Rosendale Dairy CAFO

Comment Summary and Response

Wisconsin Department of Natural Resources
February 27, 2009

Environmental Impact Statement Comment Summary and Response for Rosendale Dairy WPDES Permit

Figure 1
DNR January 2009 Dispersion Modeling Layout

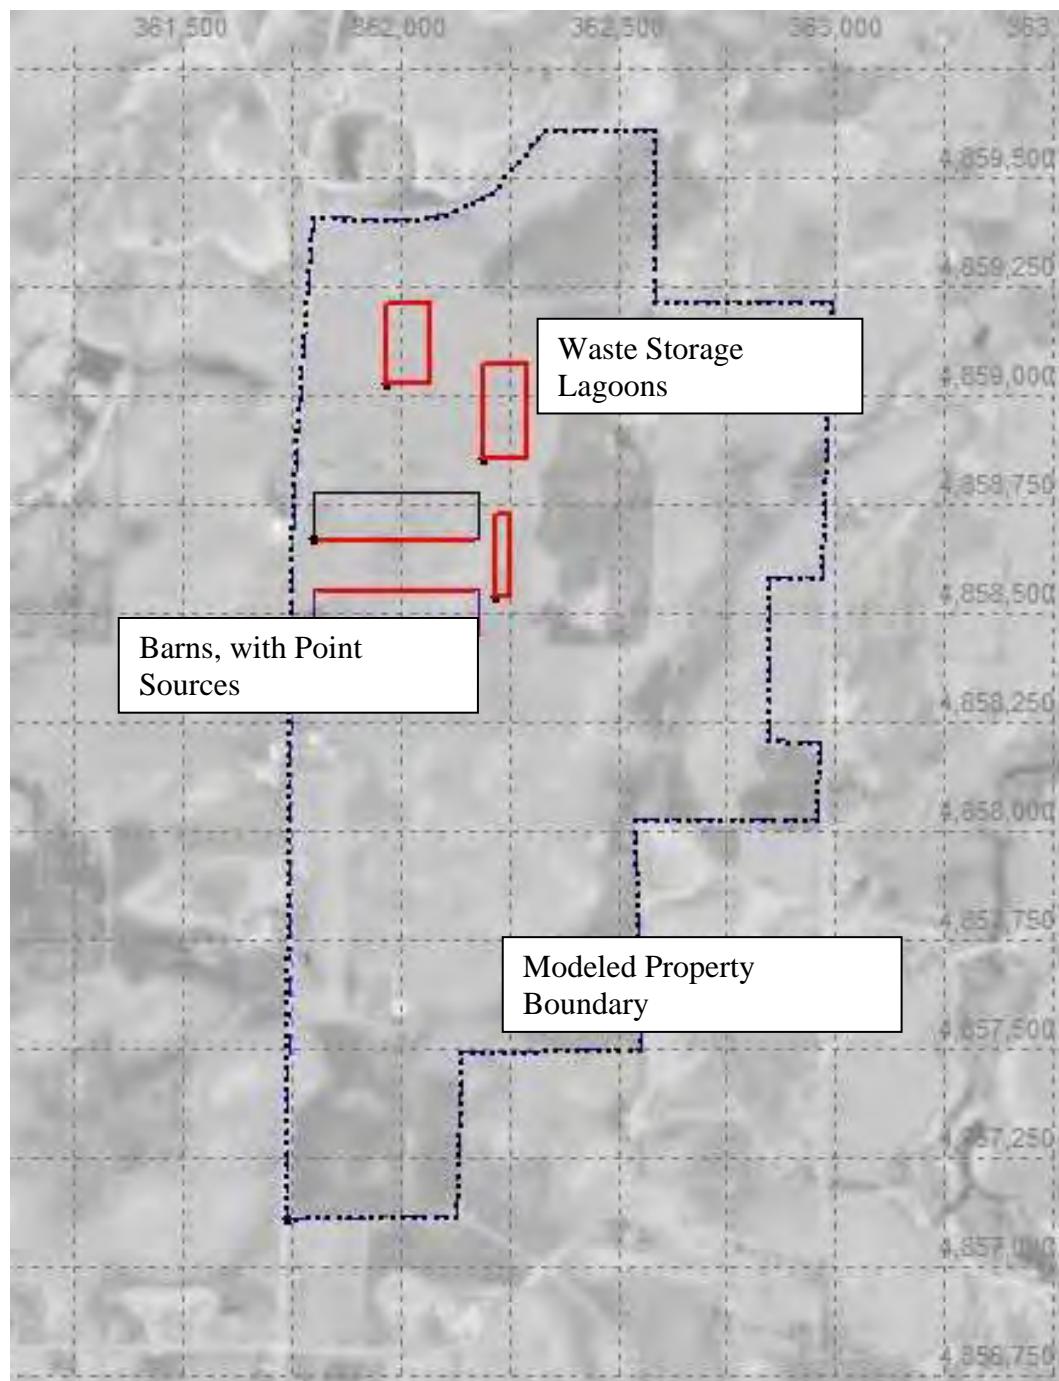
- Receptors were placed around the facility along the property boundary, as modified by the roadway network. Terrain elevations as derived from AERMAP were included. Please refer to Figure 1 for details.
